ISSUE: Permit to Demolish/Capsulate (partial) and Certificate of Appropriateness for alterations and an addition.

APPLICANT: Pat and Kerry Adams

LOCATION: Old and Historic Alexandria District
107 North Fairfax Street

Figure 1: Area to be encapsulated on E elevation

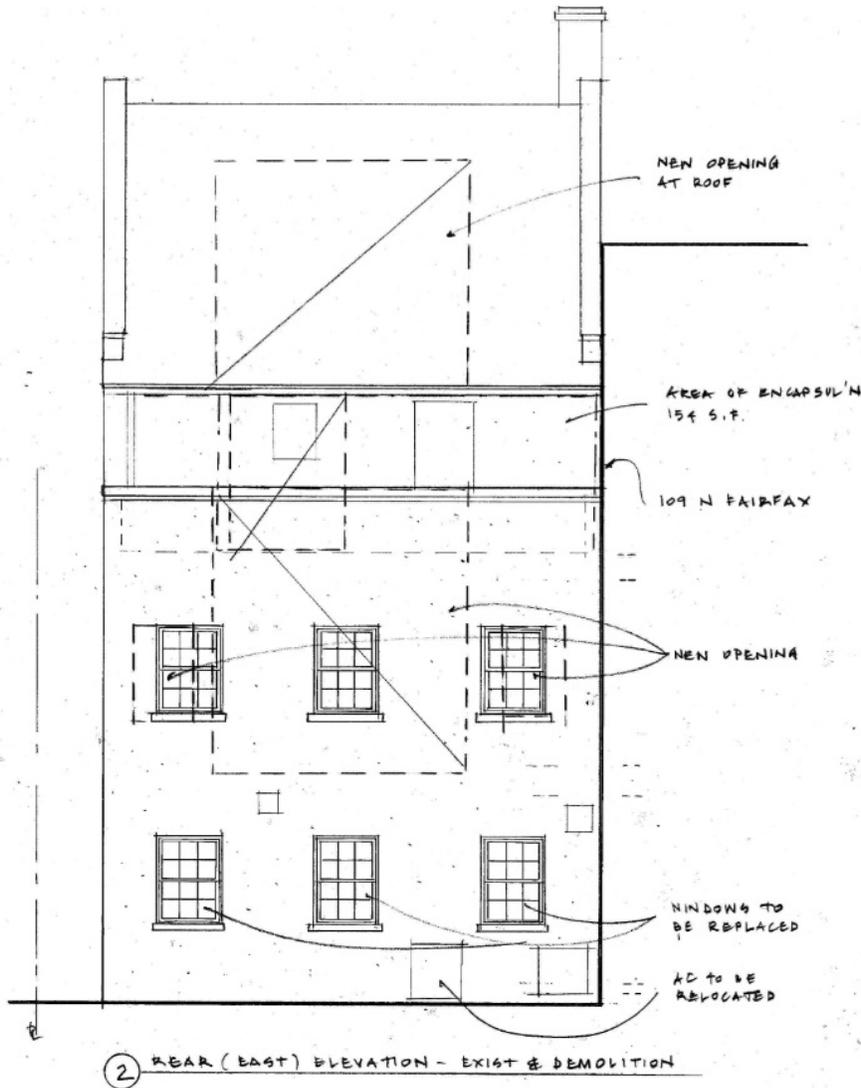
Approximately 154 square feet of wall surface will be encapsulated on the rear/east elevation. In addition, a section of roof here will be removed in order to construct a new dormer addition. See Figure 1.

The analysis of the standards indicated above relate only to the portions of the wall areas proposed for demolition/capsulation. In the opinion of staff, none of the criteria for demolition and capsulation are met and the Permit to Demolish/Capsulate should be granted. The areas proposed for demolition/capsulation are not of unusual or uncommon design and can easily be replicated. They are also not historic. As noted above, the wall on which the addition will be added was constructed in 1967 and the roof area to be affected dates to 2007.

Figure 2: Proposed E elevation.

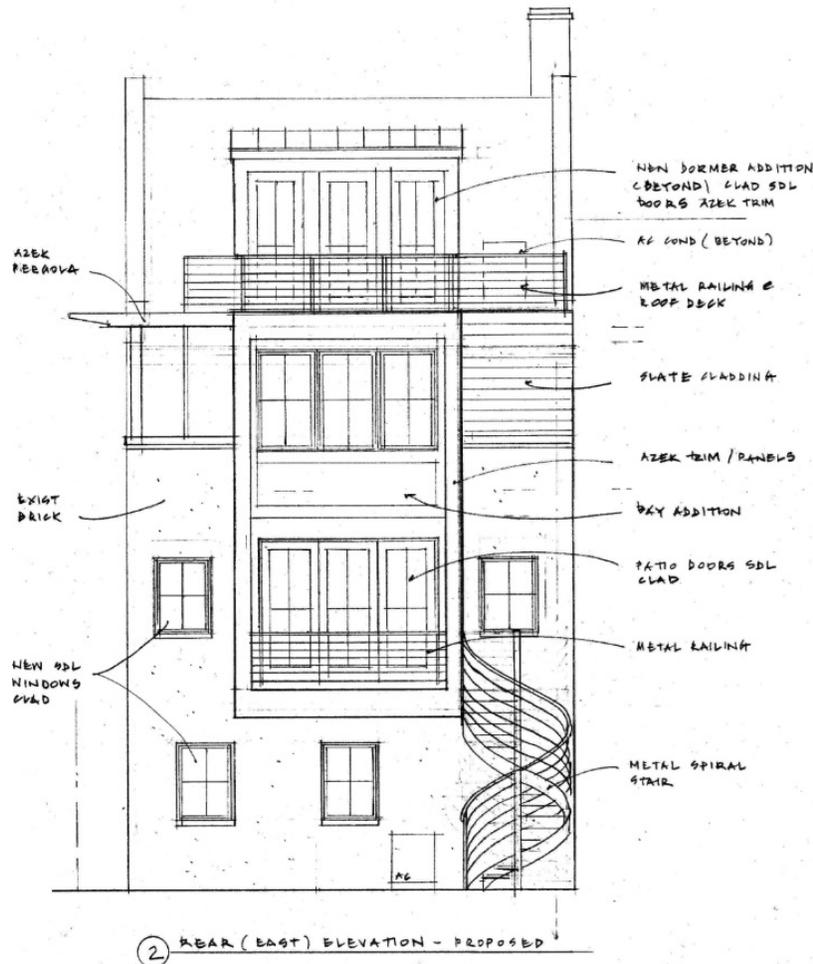
The applicant proposes a rear two-story projecting bay addition with a spiral stair and a roof deck. The addition will be appended to the second floor of the existing rear/east addition, with the new third floor and roof deck above. A dormer addition will extend from the rear/east roof of the main block. See Figure 2.

The *Design Guidelines* state that “An addition to a historic building should be clearly distinguishable from the original structure. An addition should not obscure or dilute the architectural and historic importance of an existing building by creating a false sense of the past.” As noted in the History section above, the proposed encapsulation and addition will only affect the areas of the building constructed in 1967 and the 2007 roof. Nothing of historic significance or architectural importance will be affected. All materials comply with City guidelines and policies. The window materials, as noted above, differ based on their location on the building. The rear/east

elevation will have metal railings for the roof deck, second floor patio, and spiral stair, and be clad in smooth Hardie siding. The proposed use of Azek for the trim and pergola railings, Hardie siding, and slate cladding are all appropriate for this building. In addition, these details will be minimally visible from a public right of way. Replacing the star ties on the south elevation will improve its appearance, as will replacing the door and lighting on this elevation.
